Cambridge Waste Water Treatment Plant Relocation Project Anglian Water Services Limited

Appendix 8.19: Waterbeach Pipeline Arboricultural Impact Assessment

Application Document Reference: 5.4.8.19 PINS Project Reference: WW010003 APFP Regulation No. 5(2)a

Revision No. 03 20 November 2023

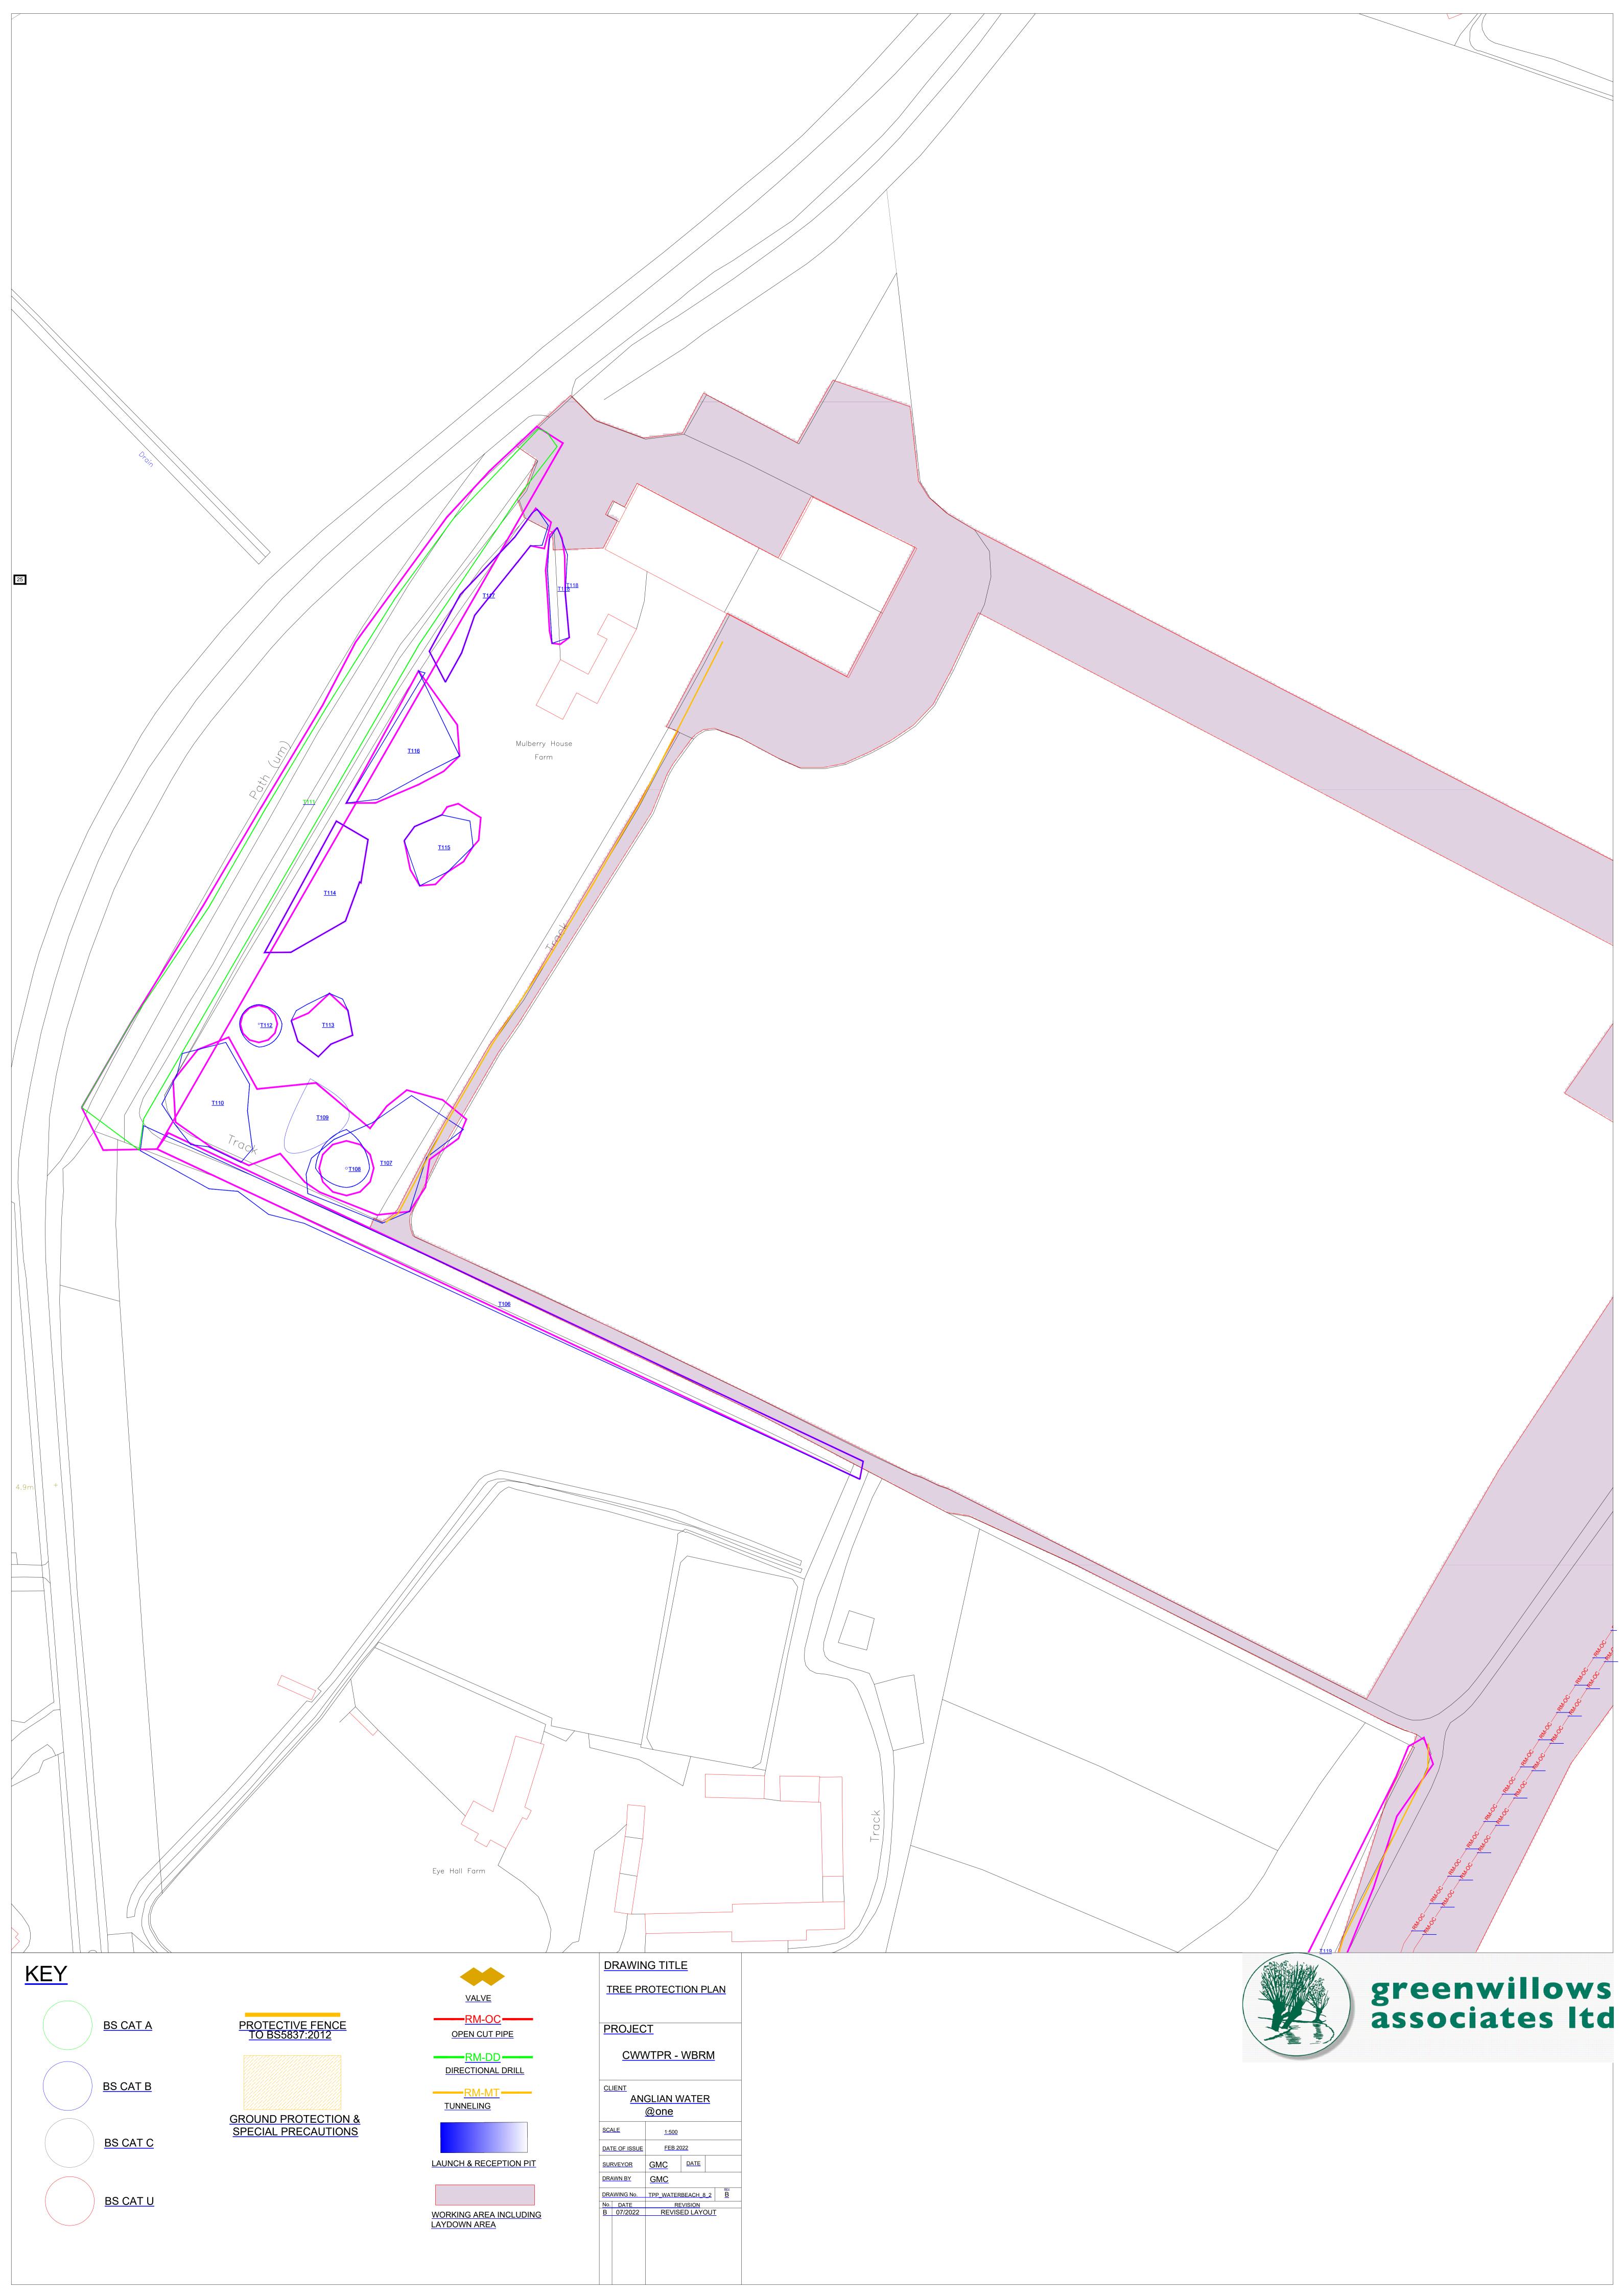
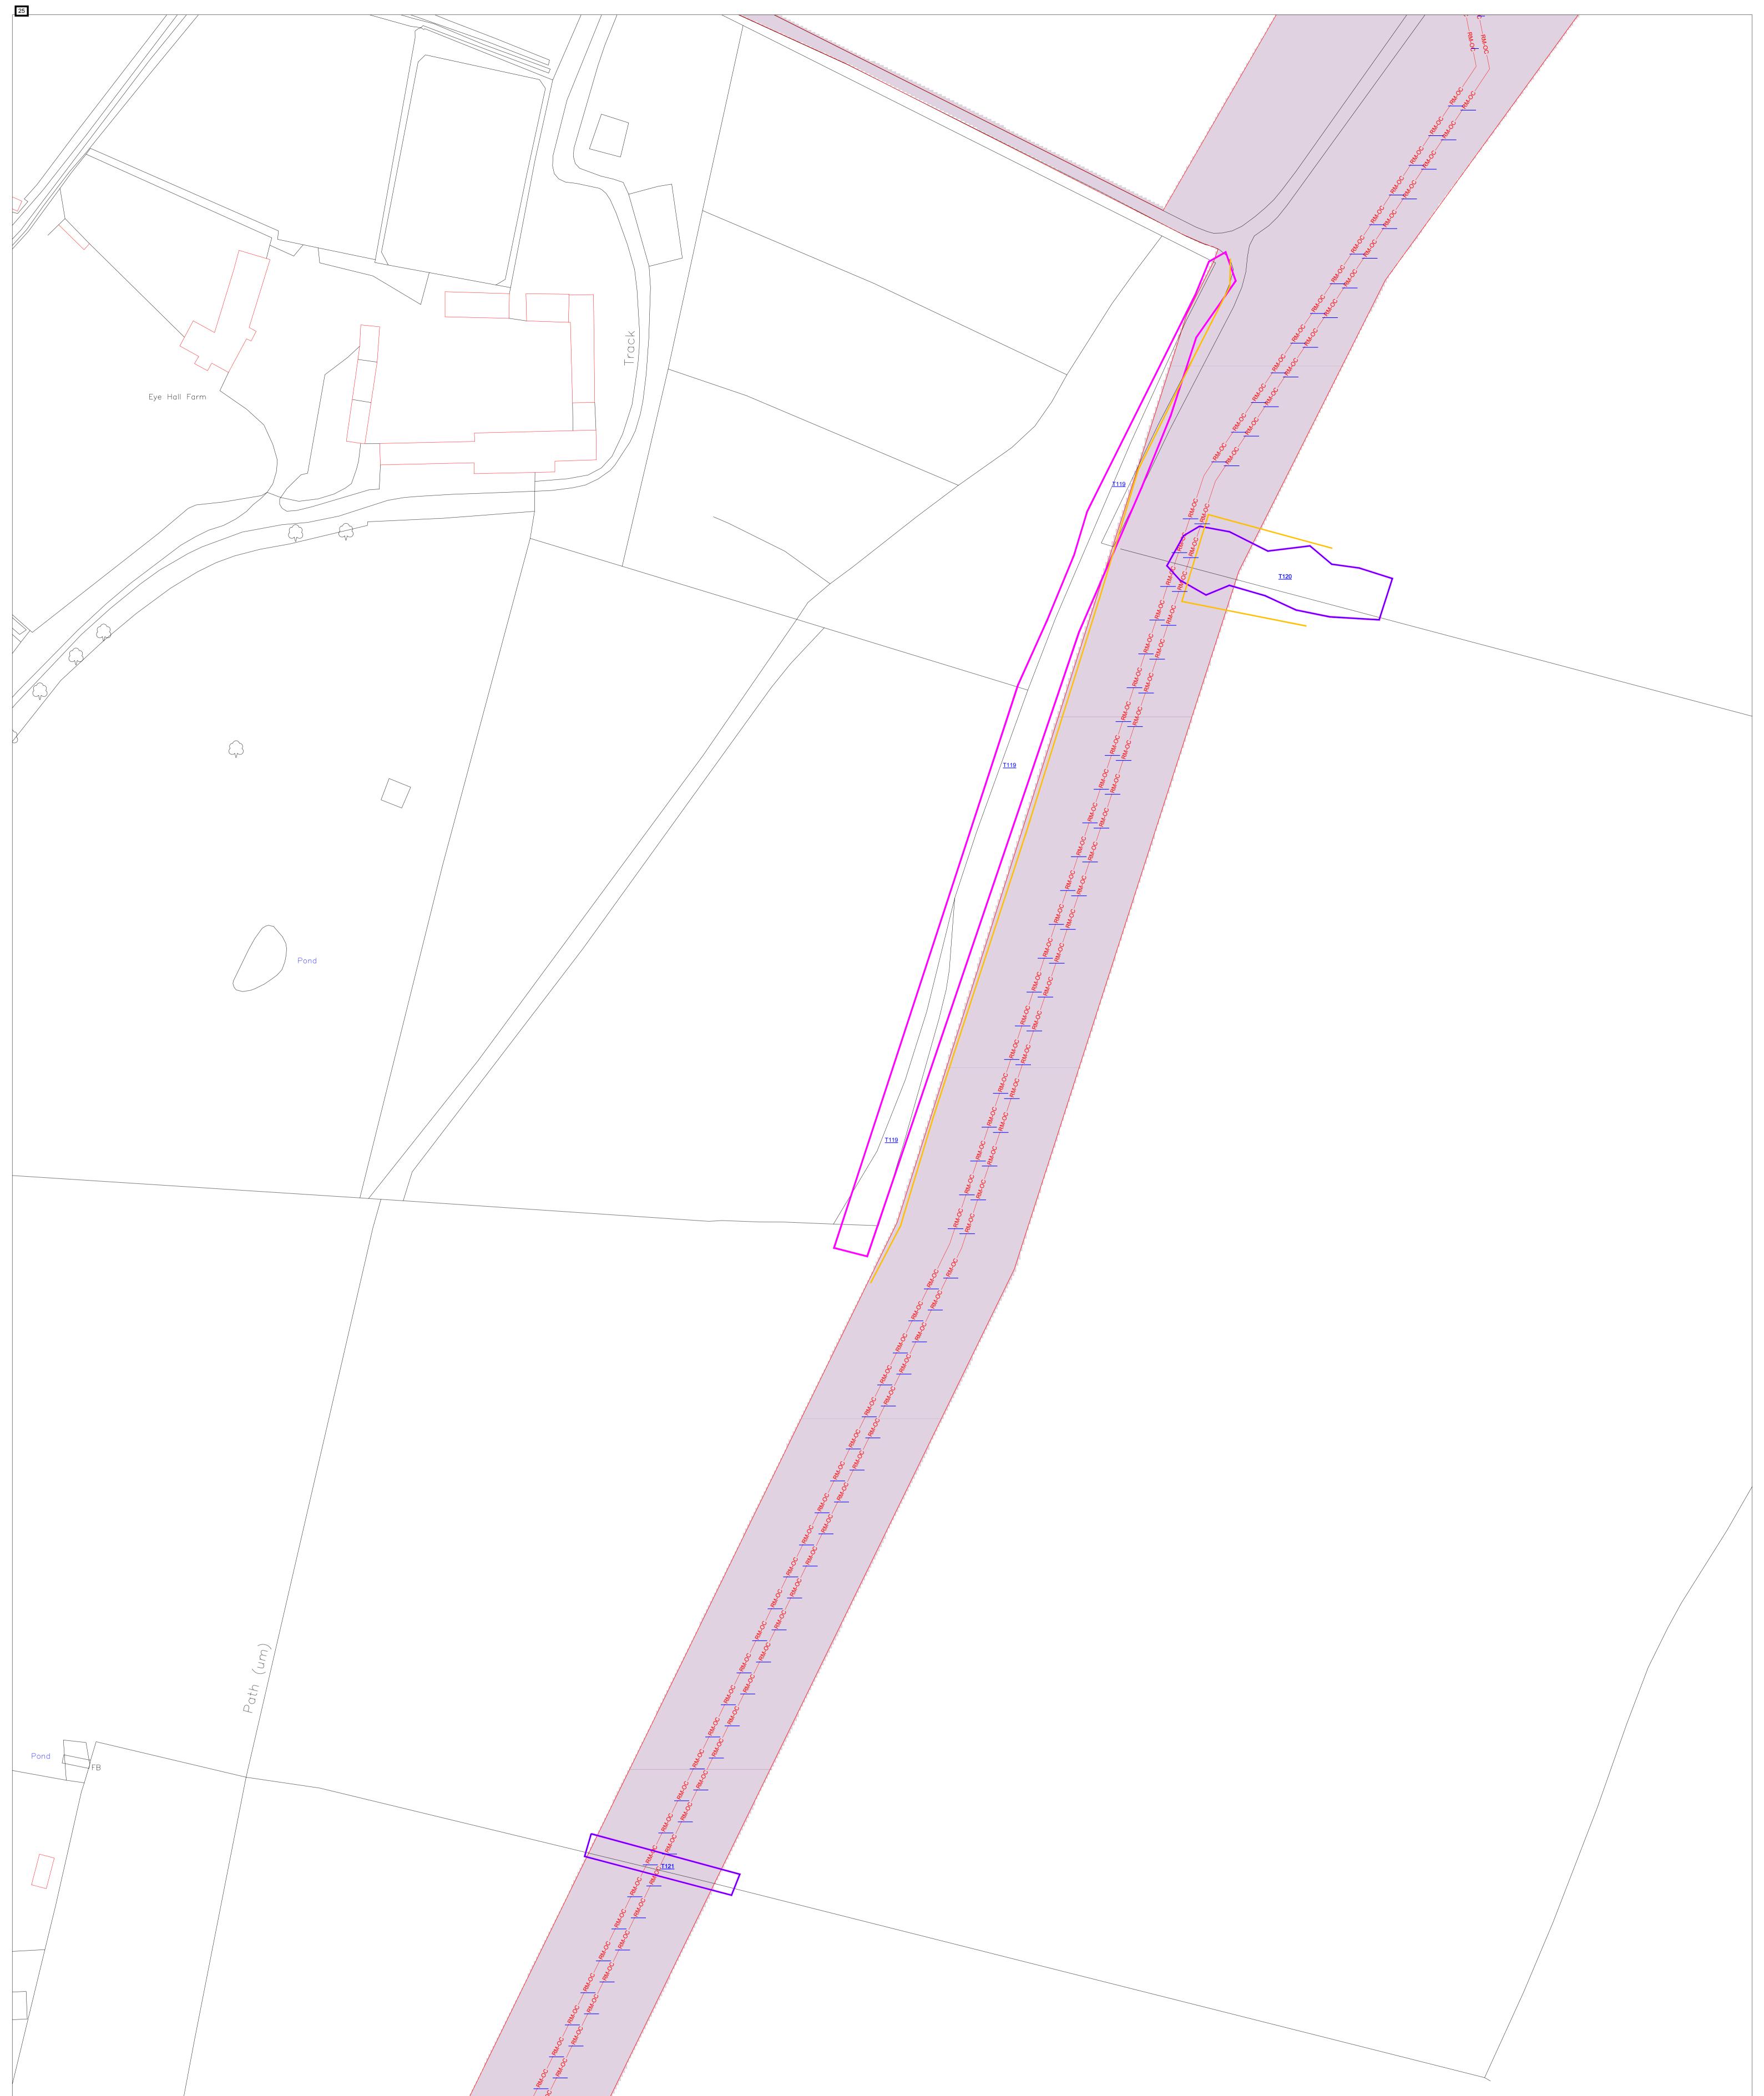
Initial comments from the Planning Inspectorate, referring to this report and the Preliminary Ecological Appraisal (PEA) stated that the Root Protection Area (RPA) for T105 should be calculated as per the Woodland Trust recommendations for the protection of the RPA.

The recommendation is that an RPA is based on 15 times the trunk diameter or 5m beyond the crown extent, whichever is the greatest. Therefore, the protective fence for tree T105 will be installed at a minimum of 16m from the trunk (based on 5m beyond the crown radius) as shown on drawing TPP WATERBEACH 7 2 Rev C and in the details in Appendix 2.
